Fish Populations - 2. Many species in the Hudson River system are actually declining. While the striped bass (SB) population is up, that increase may be the result of other management decisions and activities. Historic baseline or trend data is not substantially discussed.

Fish Populations - 3. Several commentors questioned one or more of the assumptions used in one or more of the population models; in particular, density-dependence is unproven.

Fish Protection Points - 6. Fish protection points (FPP) would provide operational flexibility but even less protection than conditions in the Hudson River Settlement Agreement (HRSA).

Fig. 6. Temperature Profile of the Hudson River, NYC to Newburgh, During a Spring Tide¹⁸⁰

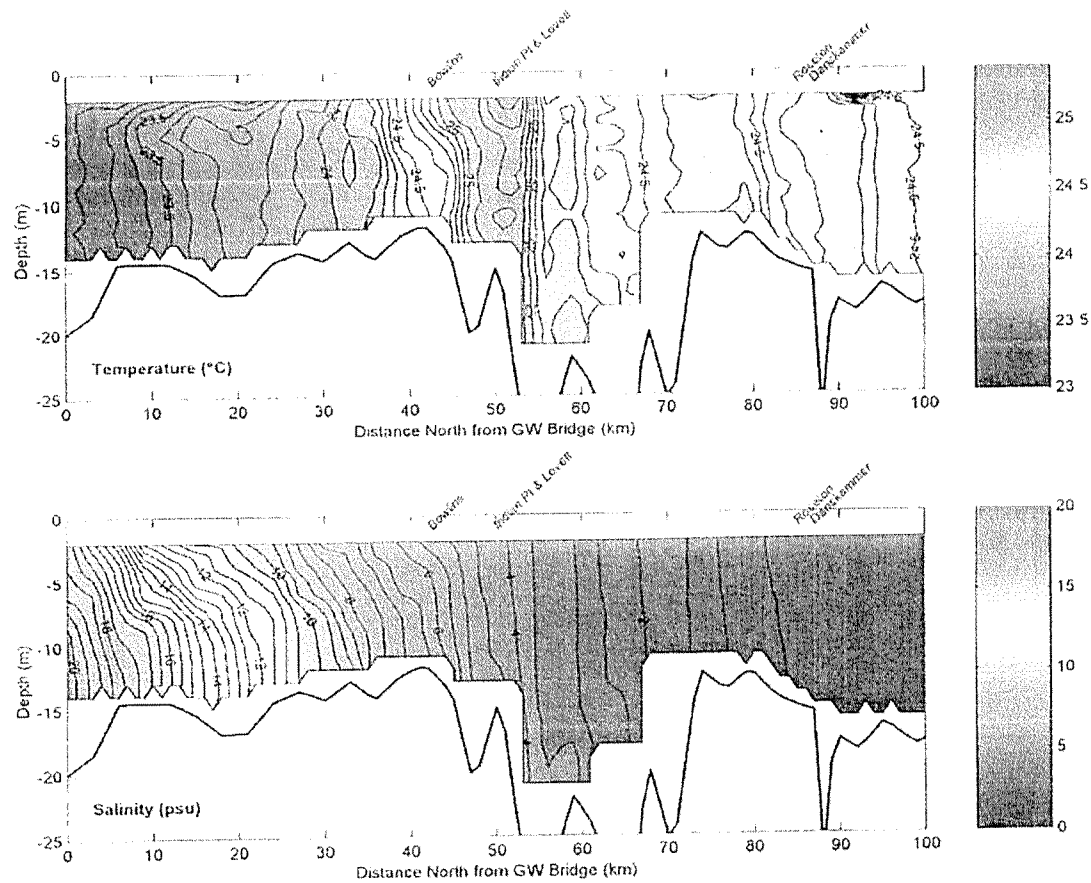
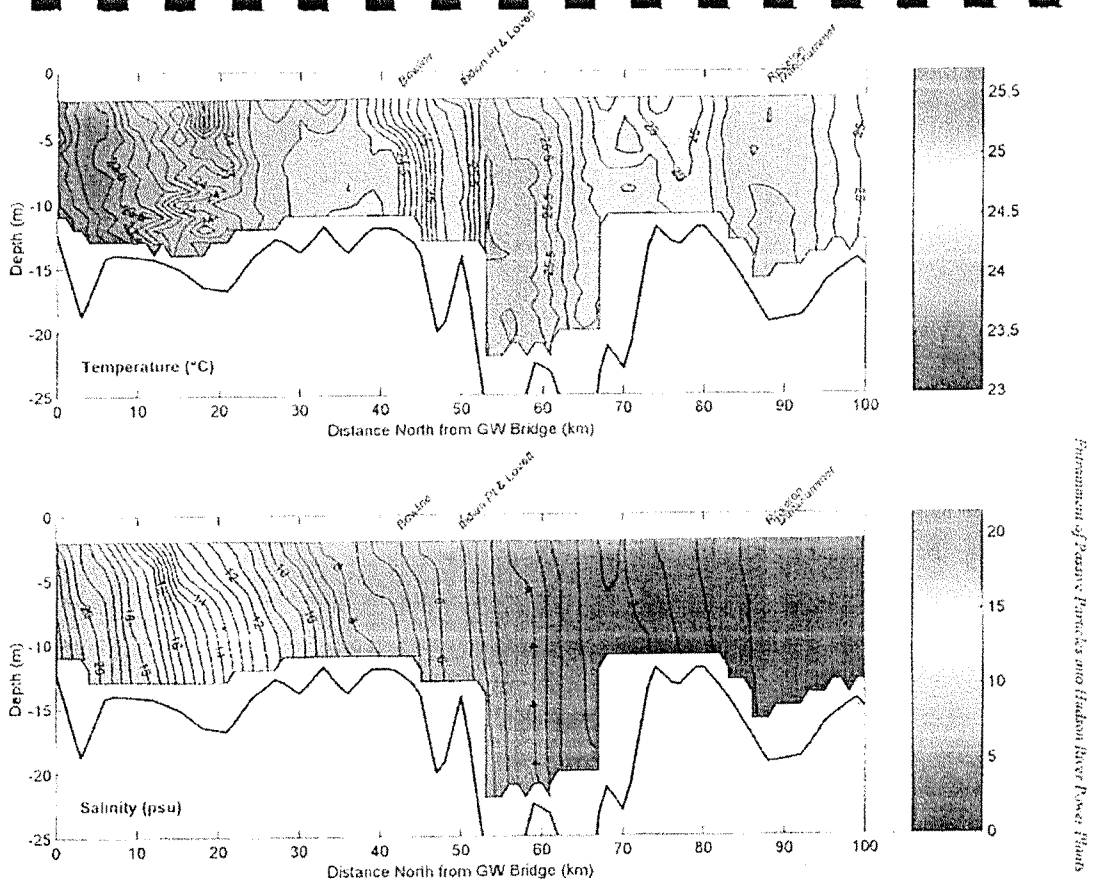
The Department concurs with this comment. Thermal discharges were inadequately addressed in the DEIS. The DEIS asserts, with no supporting evidence, that "... [t]he surface water orientation of the plume allows a zone of passage in the lower portions of the water column, the preferred habitat of the indigenous species." Other data and analyses cast doubt on this assertion.

Some graphics and imagery effectively illustrate the basis for the Department's concerns. A study by HydroQual, Inc., examined passive particle movement and also investigated thermal and salinity profiles in several river reaches, including the portion of the Hudson River where the HRSA plants are located.¹⁷⁸ Figures 6 and 7 of this FEIS (following pages), excerpted from that study, show two vertical temperature profiles of the Hudson River from NYC to just above the northernmost of the HRSA plants, one during a spring and the other during a neap tide. Based on these representations, it appears that there may be times and conditions where effluent-warmed waters occupy nearly the entire vertical water column.

**Fig.8. Thermal Plumes from Indian Point, Unit 3,
and Lovett Station, Tompkins Cove, Hudson River, New York State.**

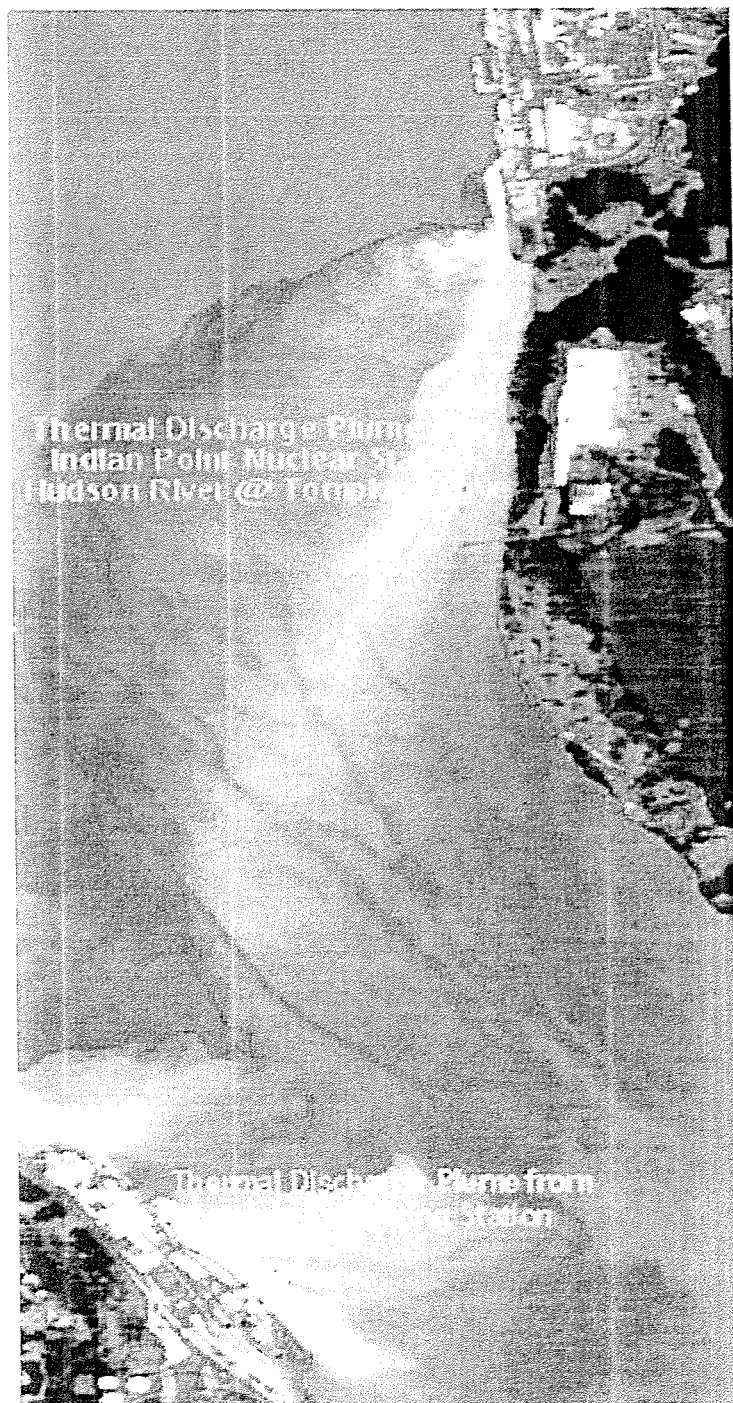
The surface extent of thermal discharges from the HRSA plants is also a concern. Figure 8 is an aerial thermal image of the plume from Indian Point, Unit 3 only, on the east side of the Hudson plus the smaller plume from Lovett on the west bank.¹⁷⁹ In this image, the two plumes came very close to meeting on the surface, even with Indian Point running at less than its full capacity.
